REVISION "E"

MARYLAND DOT - STATE HIGHWAY ADMINISTRATION

MD 197 AND MUIRKIRK ROAD

DRAWN BY: M LINARDI	F.A.P. NO. PG434433R	TS NO. 902 E	SHEET NO.
CHECKED BY:	S.H.A. NO.		1 OF 3
SCALE: 1"= 20'	COUNTY: PRINCE GEORGE'S	T.I.M.S. NO. F088	
DATE: 5-3-73	LOG MILE: 16019712.28

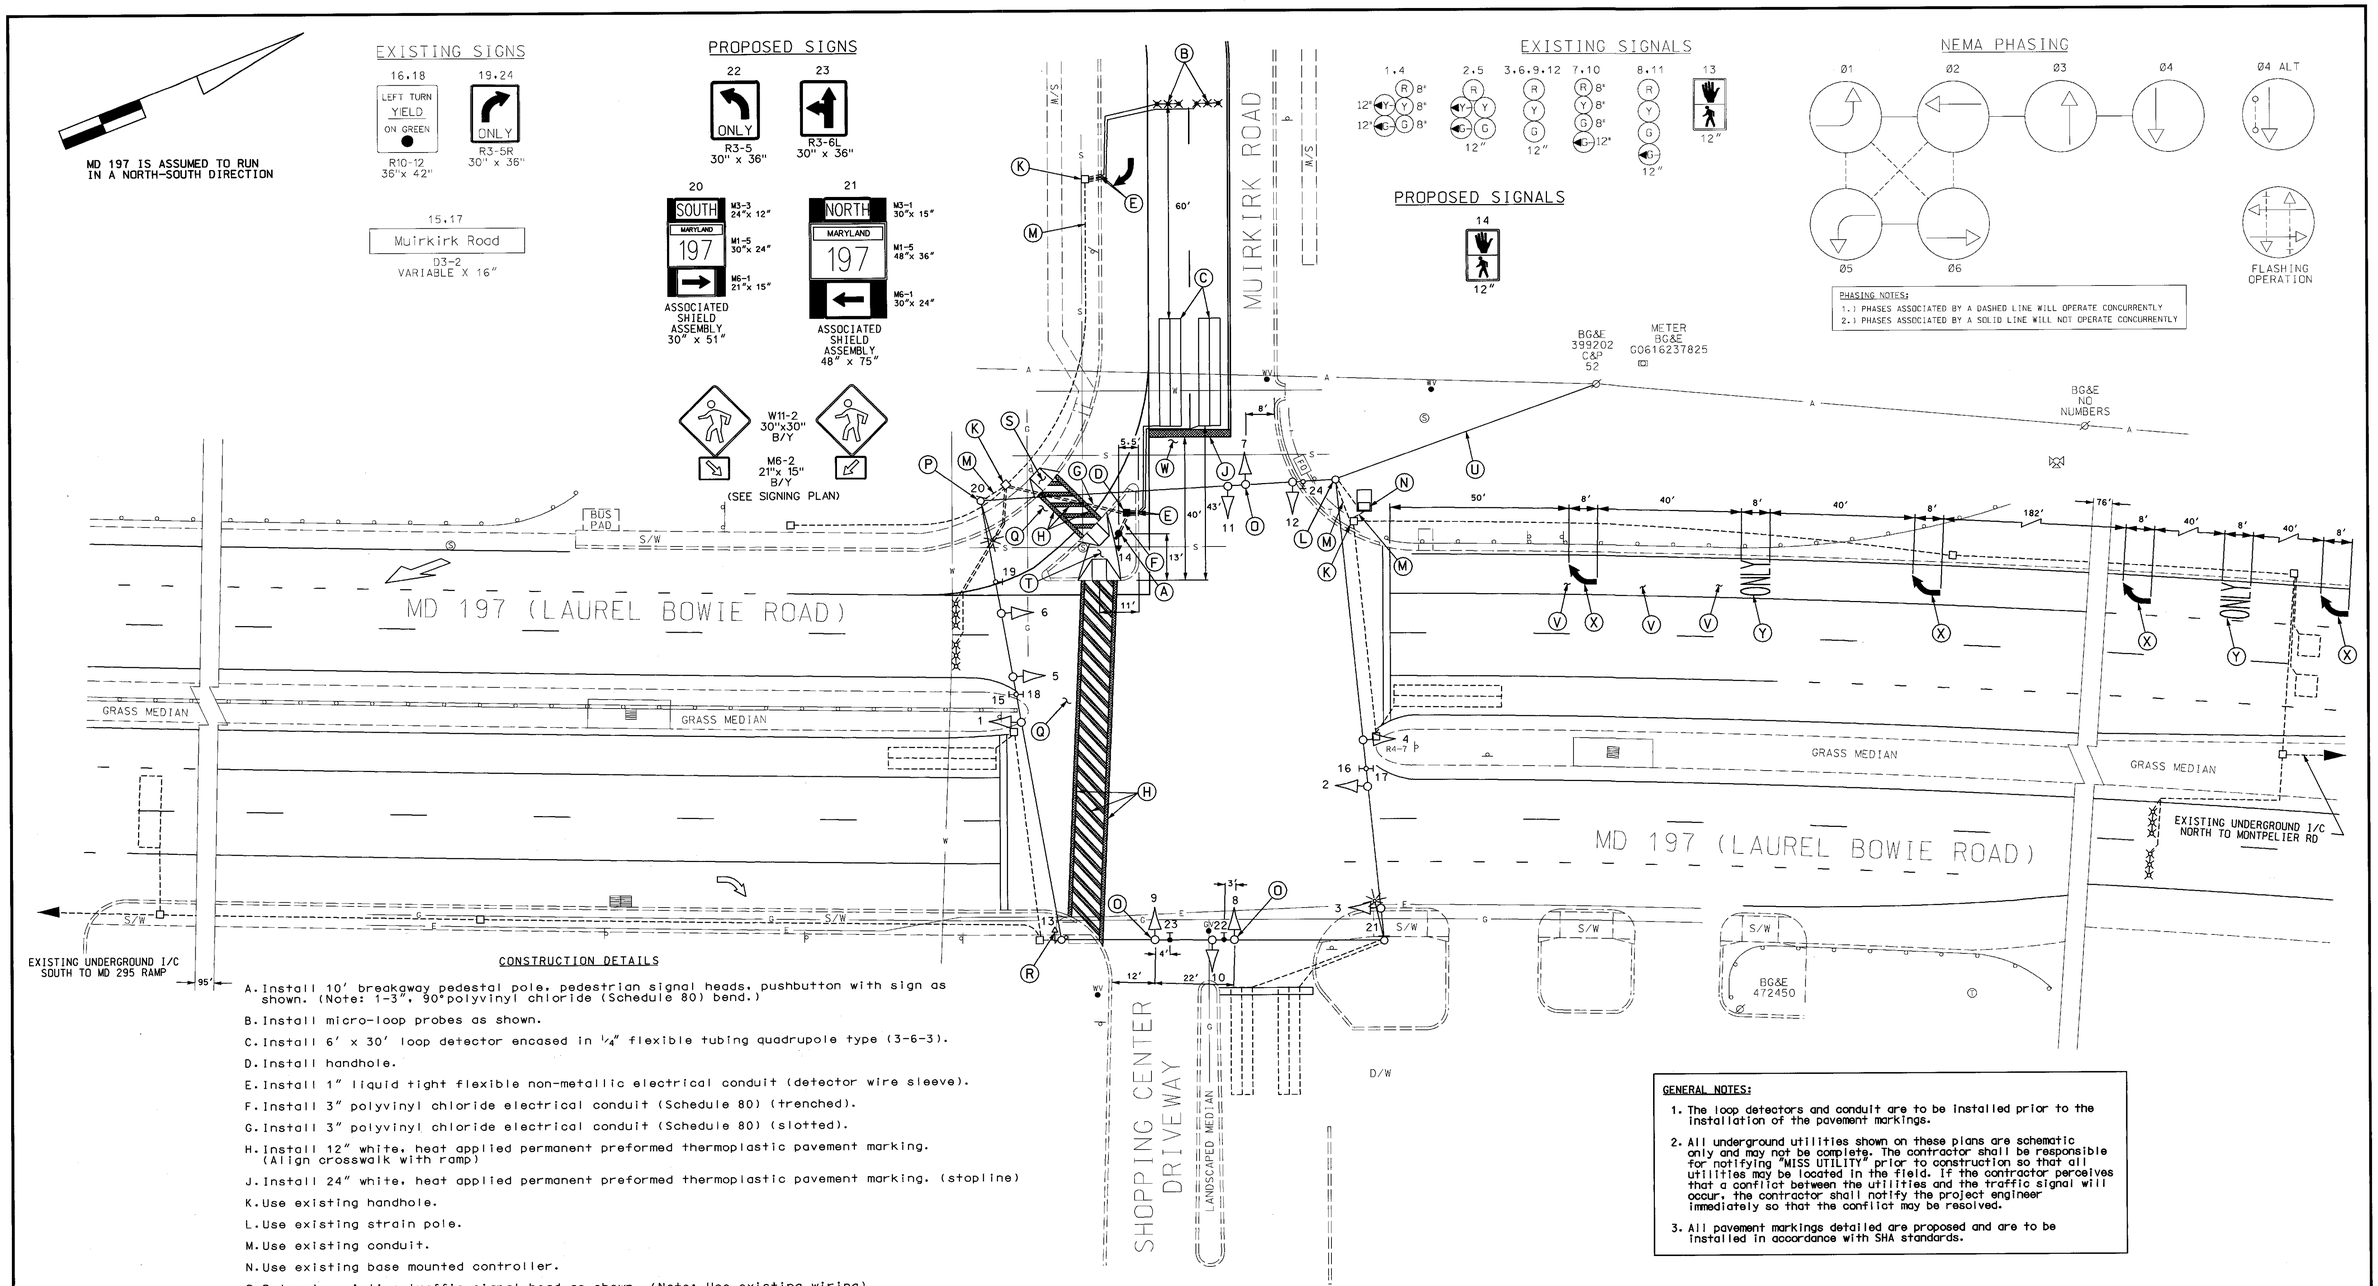
E 11-13-02
REVISE PED X-ING ON SOUTH LEG OF MD 197.
REVISE PW'S ON MUIRKIRK RD
SHA NO.: XX1065285
RRZ

H. Install 12" white, heat applied permanent preformed thermoplastic pavement marking. (Align crosswalk with ramp)

P. Remove existing pedestrian signal, education sign and pusbutton from strain pole.

Q. Remove existing pavement markings. (crosswalk)

R. Realign existing pedestrian signal head to new crosswalk.

S. Remove existing sidewalk and install handicapped ramp.

T. Install handicapped ramp.
